Project:	2022-RFT-030 821131– Solid Waste Landfill Construction		
Addendum No.	02	No. of Pages:	8
Date:	2022-05-13	Doc. No.:	P7201-1591092266-153(1.0)

The purpose of this Addendum is to clarify and answer for bidder's question on tender 2022-RFT-030 issued for bid on April 19, 2022

Item 1B

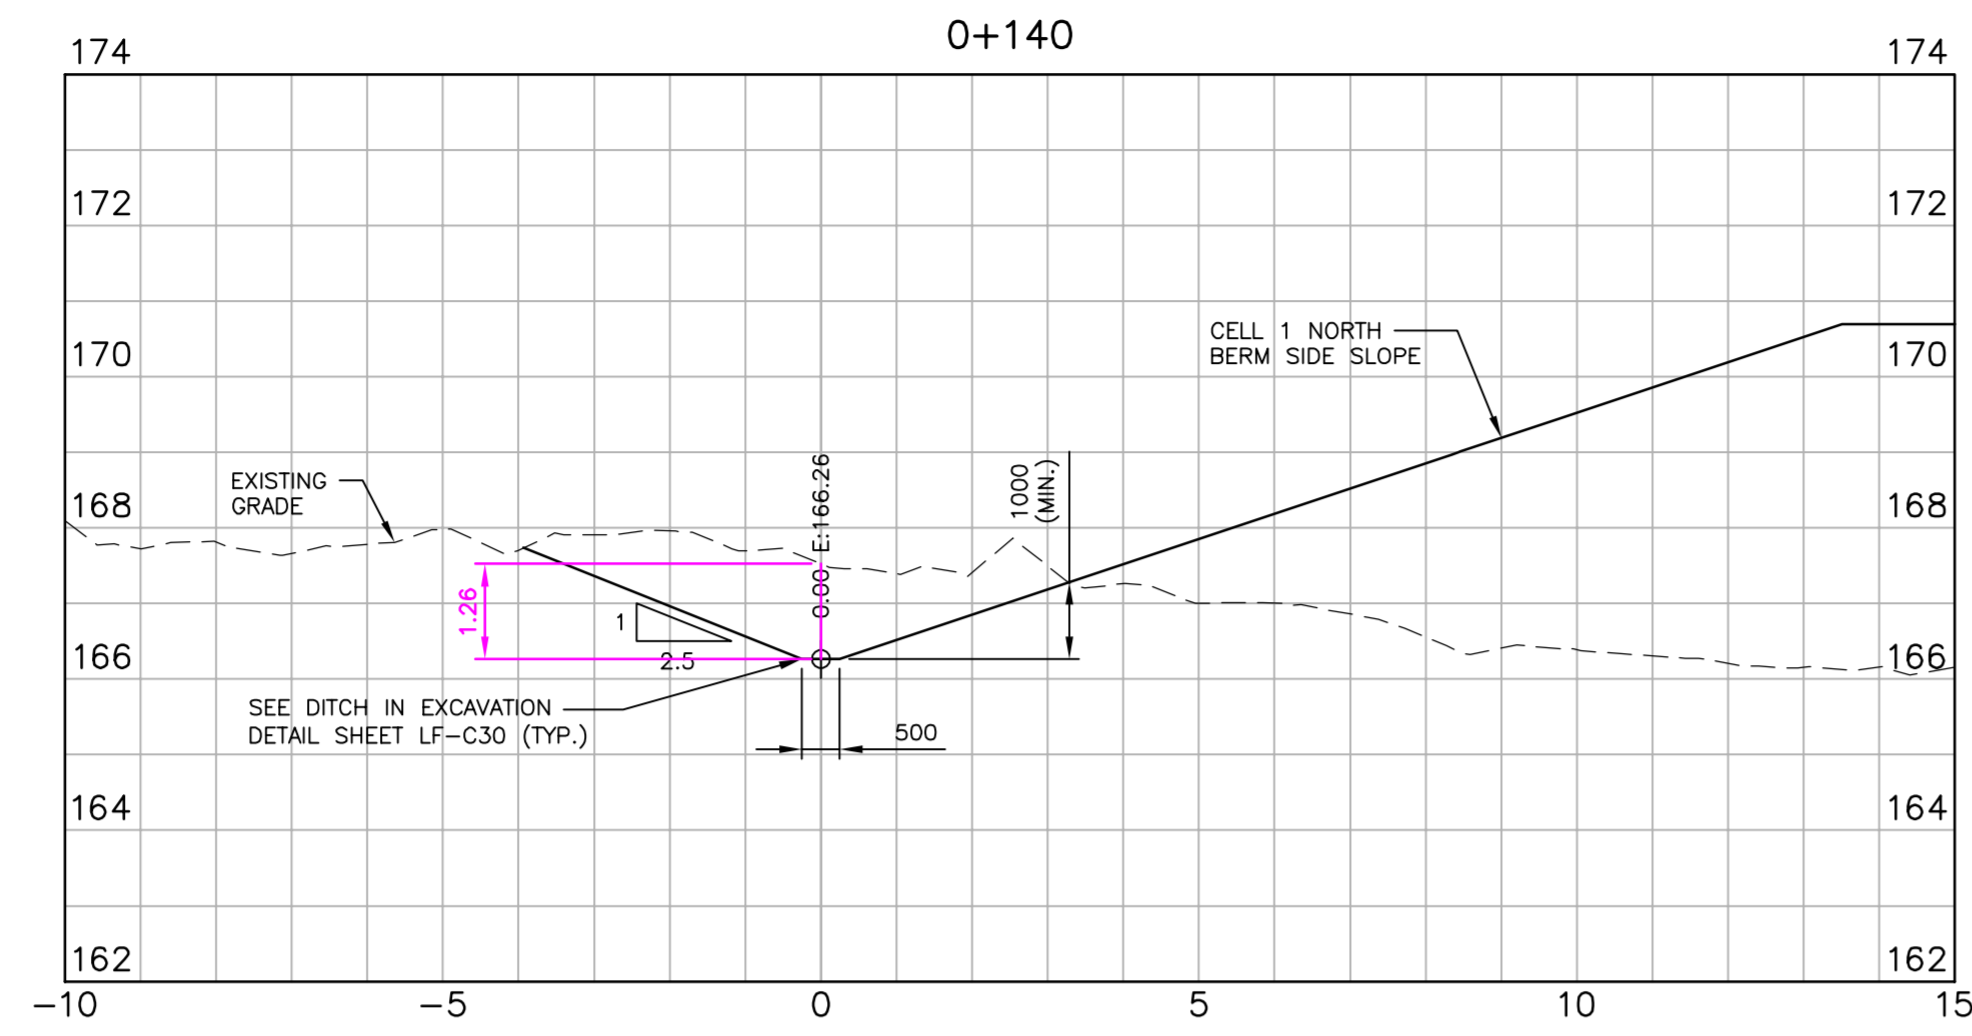
Please confirm limits of liner and geotextile for ditch as width is not clear ([Cell 1 Ditch Liner and Geotextile RFI.pdf](#))

Please see attached Item 1A and 1B.

8 SECTION
 LF-C19 1:500 H. 1:100 V.

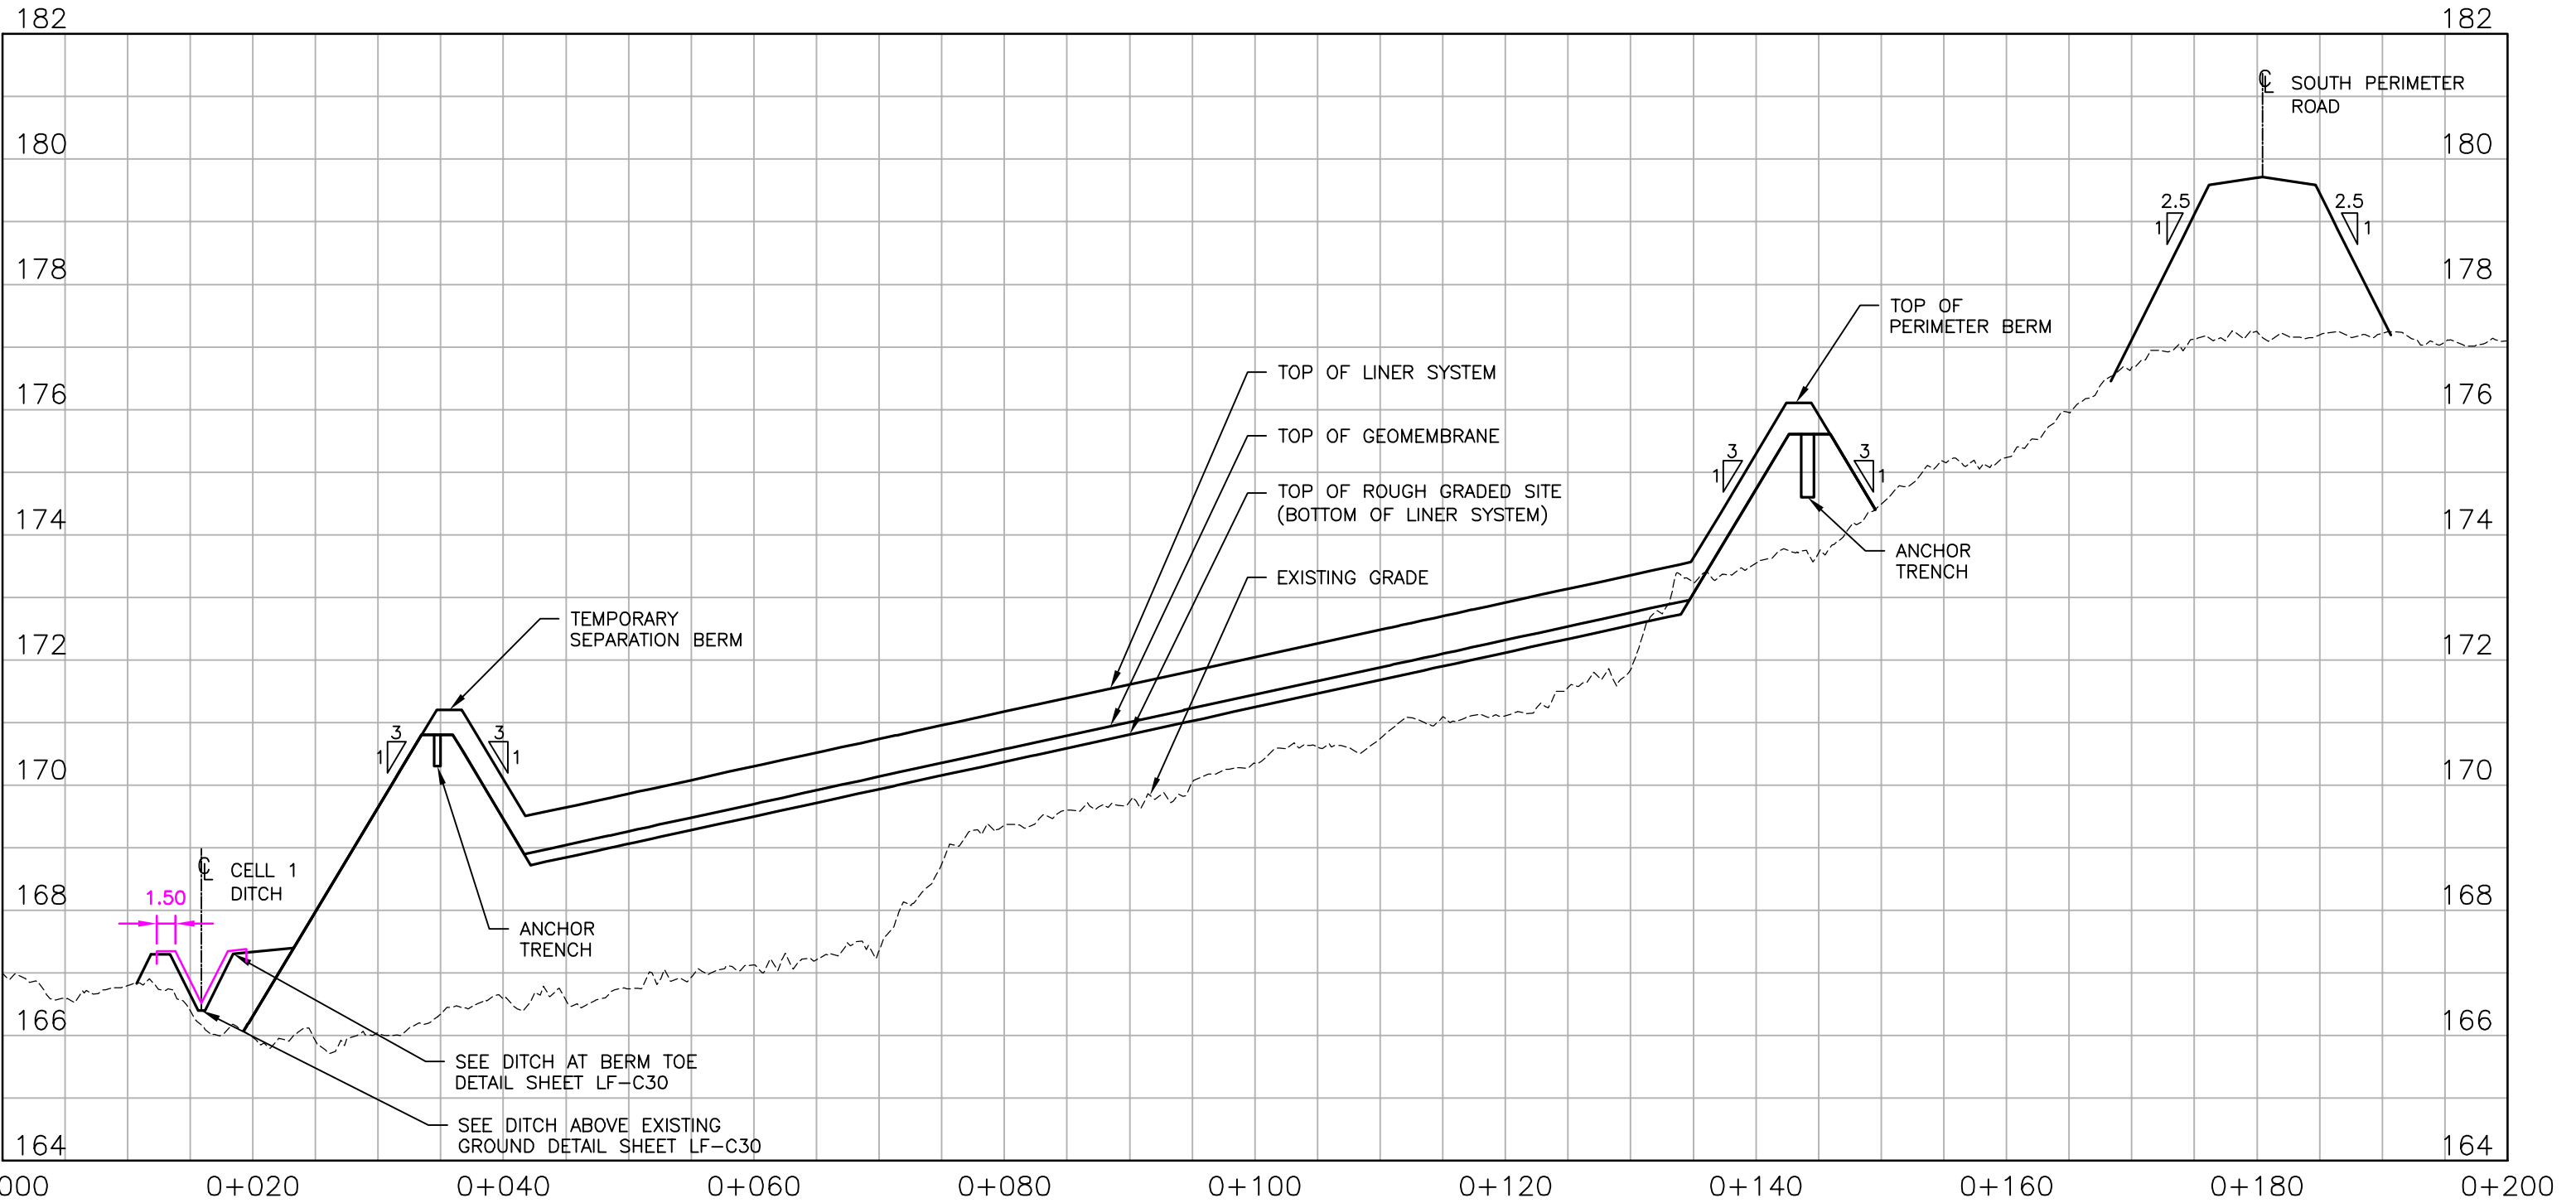
Could you please provide a specific detail for the geomembrane installation when there is a ditch in excavation plus a ditch at berm toe. (Example section 8 from drawing LF-C23 and section 9 from drawing LF-C24). We have detail on drawing LF-C30 for both ditch in excavation and ditch at berm toe but no details when they are combined.

Please see attached Item 3A and 3B.

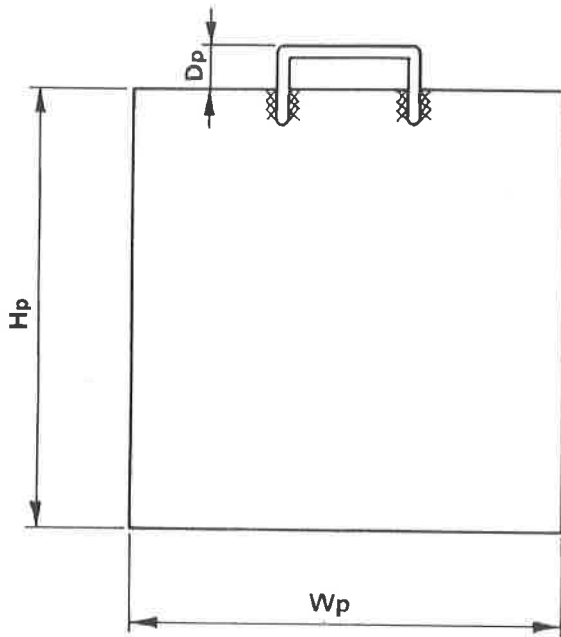
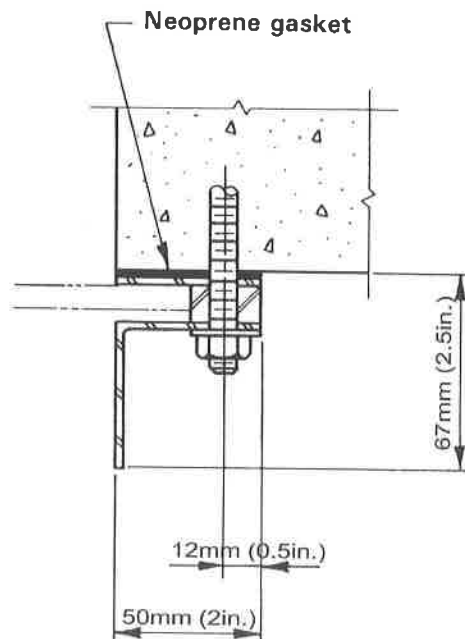
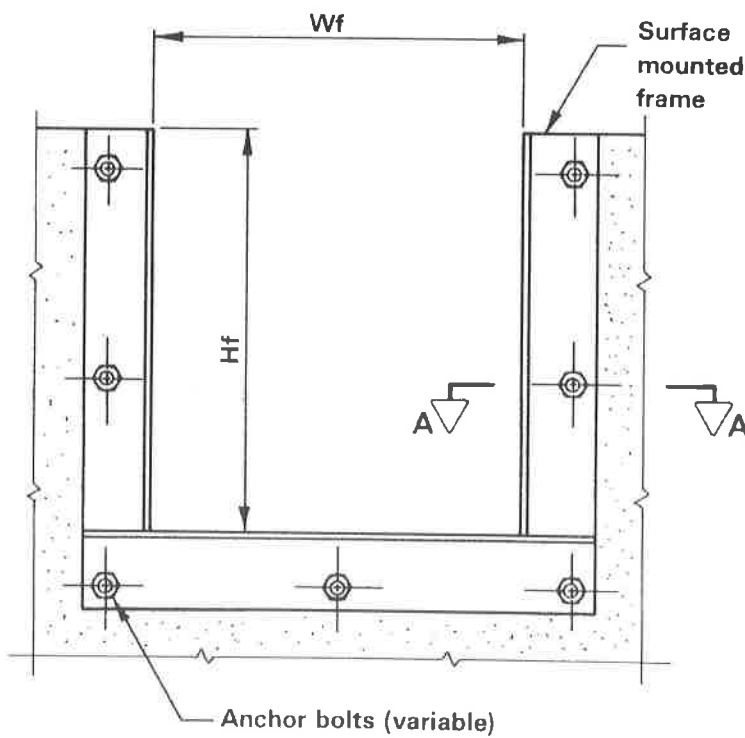
Please supply detail for the material and for the installation of the Hand Pull gate.

There are two (1500mm) control manholes indicated between Lagoon # 1& 2 and between Lagoon #2 & the level spreader. Can you please provide more details on these manholes? What are they made of? How are the pipes connected to the manhole? What is the hand pull gate made of? We require more information and details to understand how the pull gate system is fabricated and integrated within the manhole. The cover plate standard detail shown on LF-C31 does not show any hand pull gate slot.

Refer to LF-C28, near section 2 for pull gate detail. Example gate attached for reference, the material is 316 SS.

Refer to attached details for typical MH and gate, and Question 16 of this addendum.
